UNITED STATES PATENT AND TRADEMARK OFFICE

APPLICATION NO.	FILING DATE	FIRST NAMED INVENTOR	ATTORNEY DOCKET NO.	CONFIRMATION NO.
09/674,304	08/06/2001	Yutaka Yamagata	107734	5220

Office Action Summary	Application No.	Applicant(s)	
	09/674,304	YAMAGATA ET AL.	
	Examiner	Art Unit	
	Brian R. Gordon	1743

DETAILED ACTION

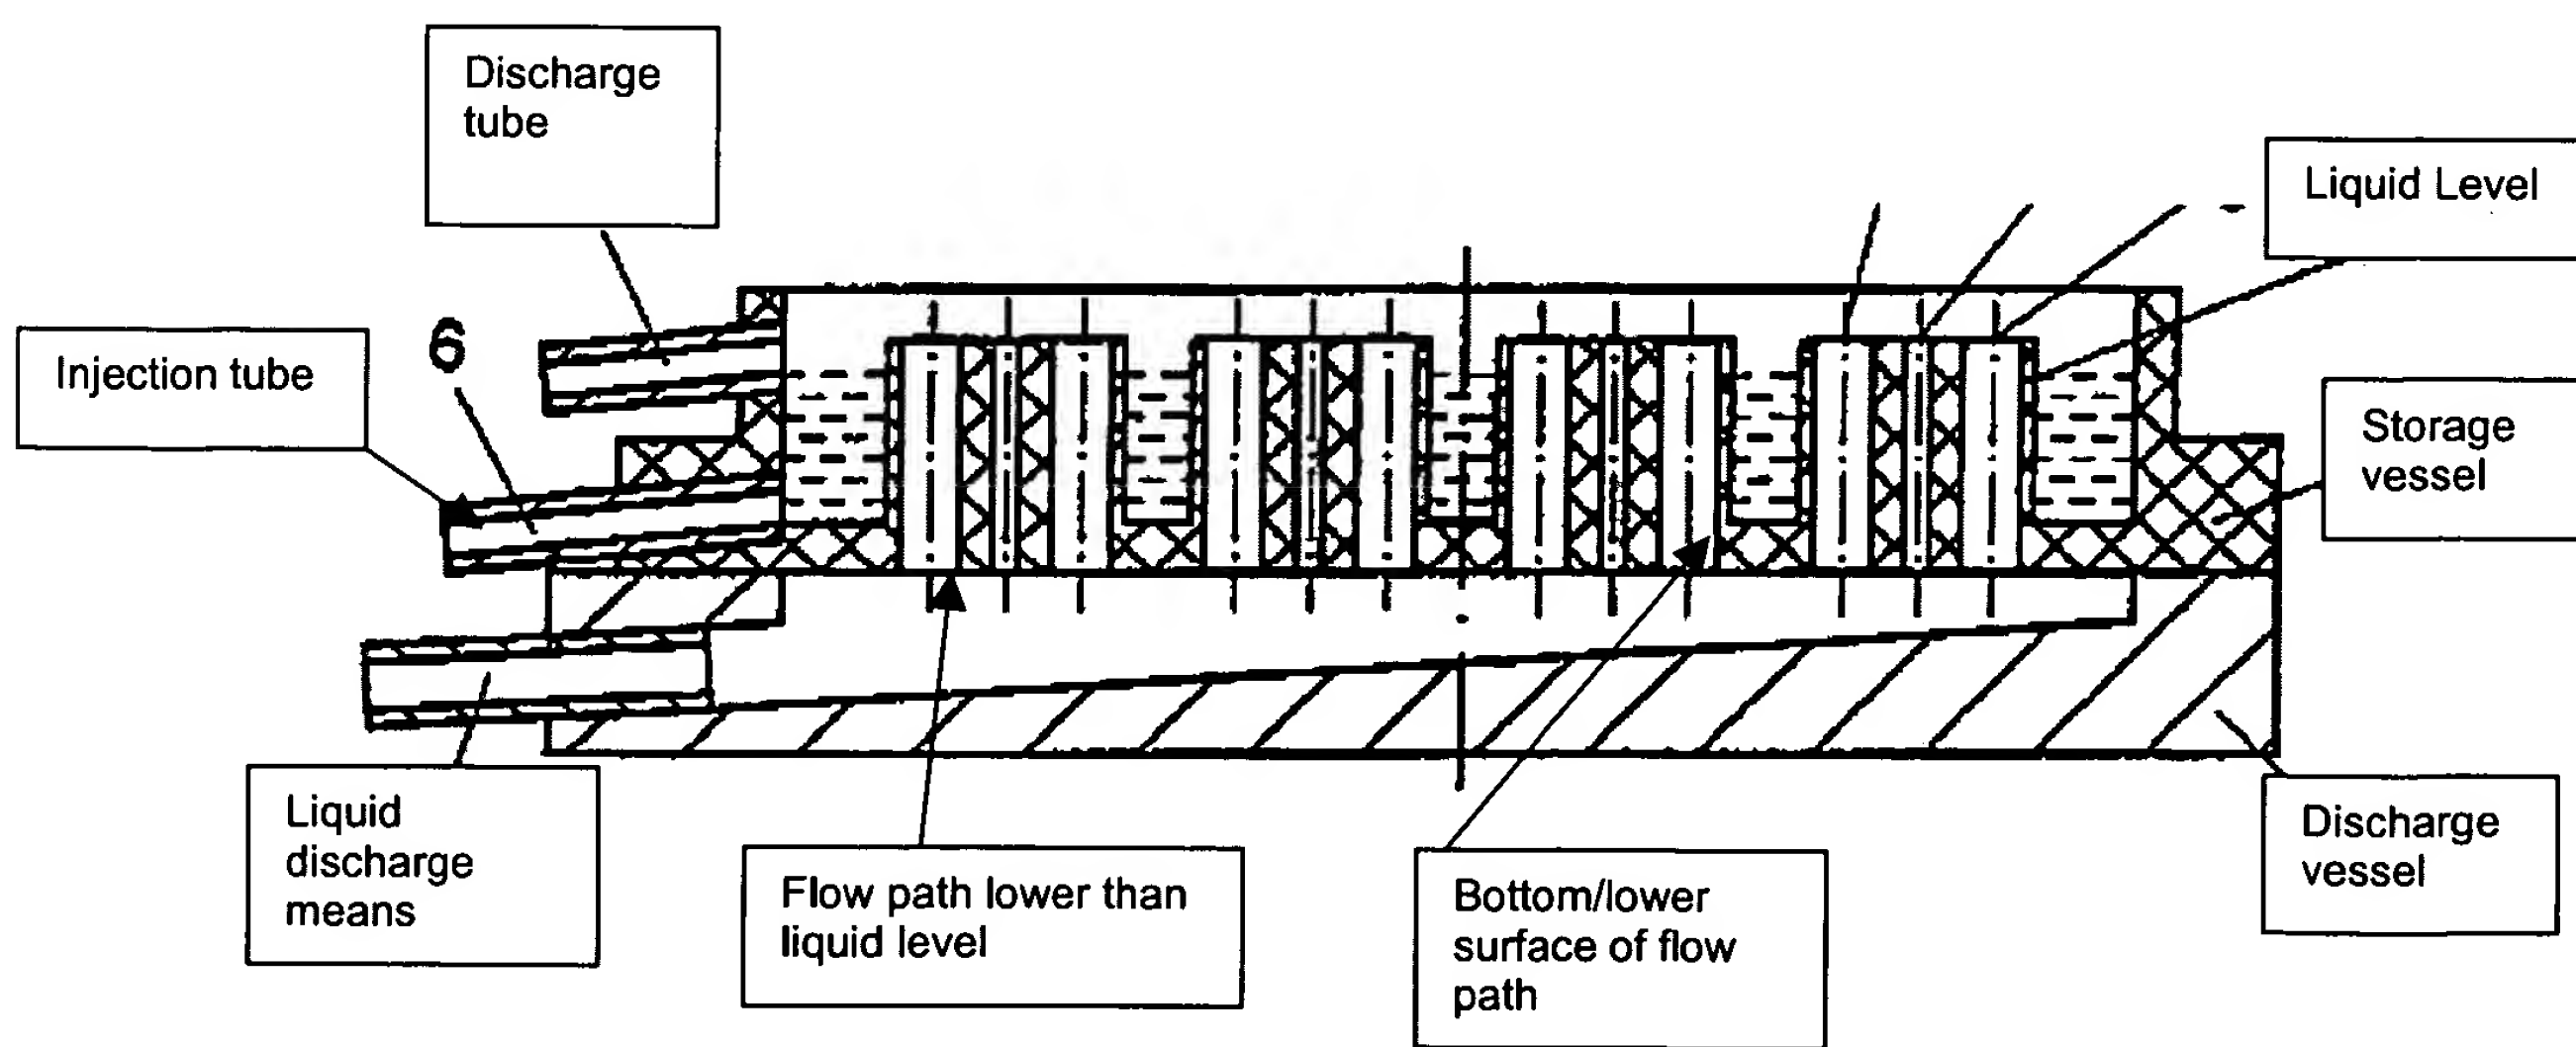
The following figure has been labeled with applicant terms as to show what the elements of the reference are considered equivalent to those claimed by applicant.

As to claim 3, it can be seen in the Figure above, that while not specifically stated, the total surface area of the bottom tray appears to be much larger than that of the top tray which has numerous openings therethrough, reducing the surface area.

As to claim 4, the discharge vessel of the device as labeled above takes on the form of a denary.
